CITY PLAN COMMISSION**THURSDAY NOVEMBER 17, 2022****FILE NUMBER:** S223-019**SENIOR PLANNER:** Sharmila Shrestha**LOCATION:** Duncanville Road, south of Ledbetter Drive**DATE FILED:** October 20, 2022**ZONING:** IR**CITY COUNCIL DISTRICT:** 3 **SIZE OF REQUEST:** 29.12-acres**MAPSCO:** 62F**OWNERS:** LB DR LLC/ 4307 DR LLC, Felix Bahena Solano, Dagoberto Guzman
Bahena, Umberto Guzman Bahena**REQUEST:** An application to replat a 29.12-acre tract of land containing part of City Block 8035 and all of Lot 66A in City Block 8035 to create one lot on property located on Duncanville Road, south of Ledbetter Drive.**SUBDIVISION HISTORY:**

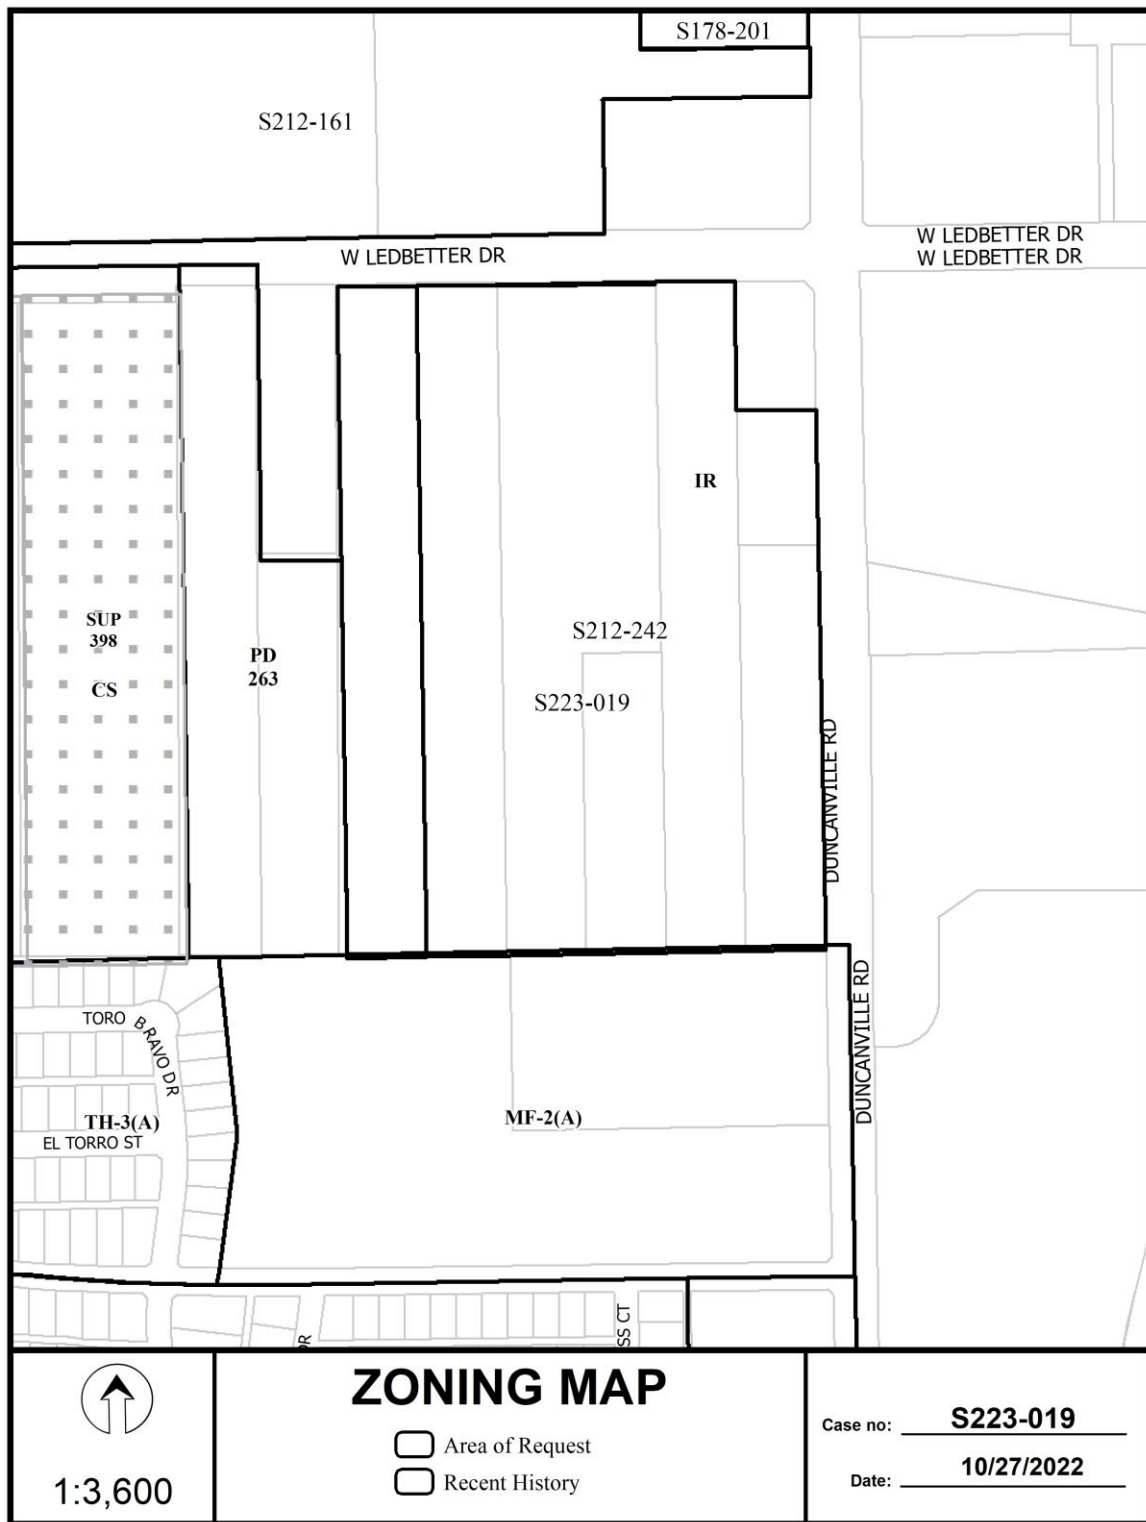
7. On the final plat, include two boundary corners tagged with these coordinates: "Texas State Plane Coordinate System, North Central Zone, North American Datum of 1983 on Grid Coordinate values, No Scale and no Projection."

8. On the final plat, monument all set corners per the Monumentation Ordinance. Prior to submittal of the final plat for the Chairman's signature, the monuments must be verified by the Chief City Surveyors Office in the Public Works Department. Section 51A-8.617

11. The number of lots permitted by this plat is one.

15. On the final plat, dedicate 53.5 feet of right-of-way (via fee simple) from the established center line of Ledbetter Drive. Section 51A 8.602(c).
16. On the final plat, dedicate 50 feet of right-of-way (via fee simple) from the established center line of Duncanville Road. Section 51A 8.602(c).
17. Existing drainage conveyance within the property is required to be sized in compliance with Section 51A-8.611(a)(1) of the City of Dallas Code.

18. On the final plat, show recording information on all existing easements within 150 feet of property.

19. On the final plat, reference board of “Professional Engineers and Land Surveyors” in Surveyor’s statement.

23. On the final plat, change “W Ledbetter Drive/ County Road 180” to “Ledbetter Drive”.
24. On the final plat, identify the property as Lot 64A in City Block 8035. Ordinance 1A, Page 131 pages 131-148, Section 2 (passed August 13, 1872).
